# SPURRIER'S SUNSWEPT ACRES 2ND ADDITION

## SEDGWICK COUNTY, KANSAS

RE: SUB 2000-90 -- One-Step Final Plat of SPURRIER'S SUNSWEPT ACRES SECOND ADDITION

RE: SUB 2000-90 -- One-Step Final Plat of SPURRIER'S SUNSWEPT ACRES SECOND ADDITION

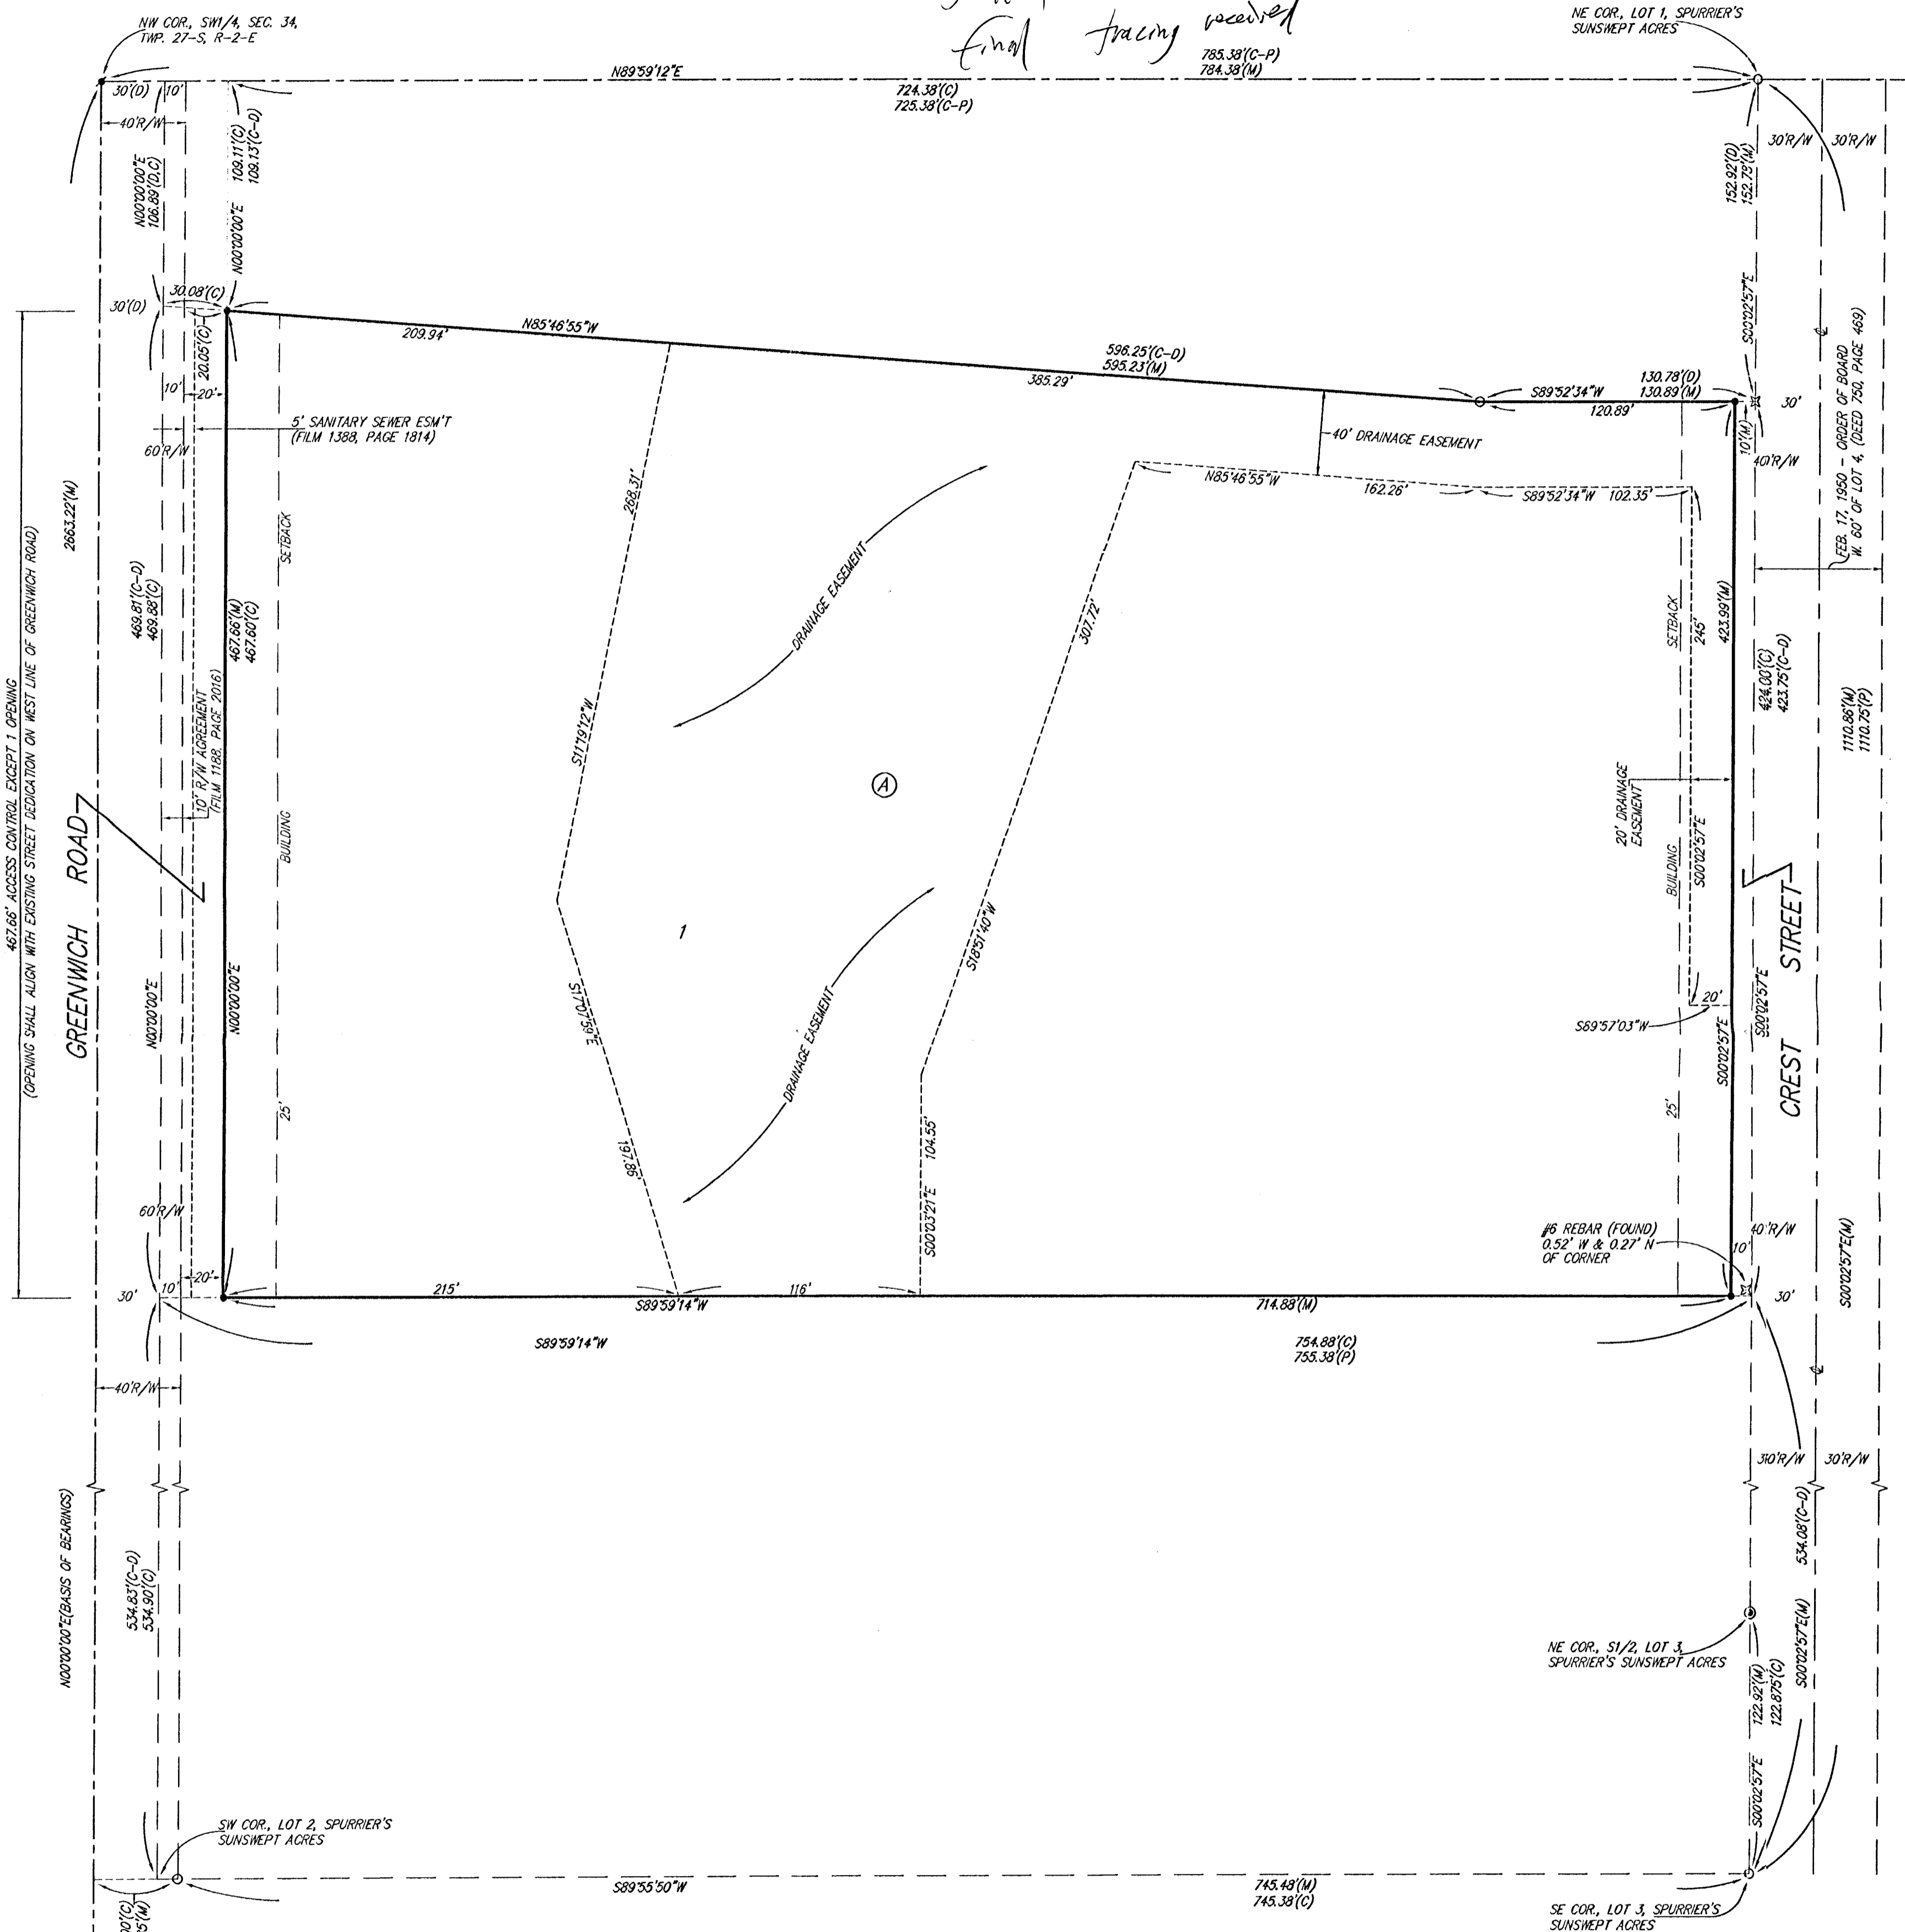
- G. *County Engineering* needs to comment on the status of the applicant's drainage plan. *A drainage easement and guarantee is needed for improvement from the cross-road culvert on Crest Street, west to the pond.*

- H. County Engineering needs to comment on the need for access controls. Distances should be shown for all segments of access control. The final plat tracing shall reference the access controls in the platlor's text. Access control except for one opening needs to be dedicated along Greenwich.

- I. The MAPC Chairman should be revised to reference "Christopher S. Carraher".
- J. County Engineering needs to comment on the need for additional right-of-way along Greenwich or Crest Street. An additional 10 feet of right-of-way is needed along Crest Street. An additional 20 feet of right-of-way is needed along Greenwich (60-ft half street right-of-way).

- K. The plat should be revised by replacing Mt. Vernon with Clark Street.
- L. A benchmark elevation needs to be added on the final plat tracing.
- M. The applicant is reminded that a platting binder is required with the final plat. Approval of this plat will be subject to submittal of this binder and any relevant conditions found by such a review.

- N. The platlor's text shall include language that a drainage plan has been developed for the plat and that all drainage easements, rights-of-way, or reserves shall remain at established grades or as modified with the approval of the applicable City or County Engineer, and unobstructed to allow for the conveyance of stormwater.

"The plat should dedicate complete access control along Greenwich."
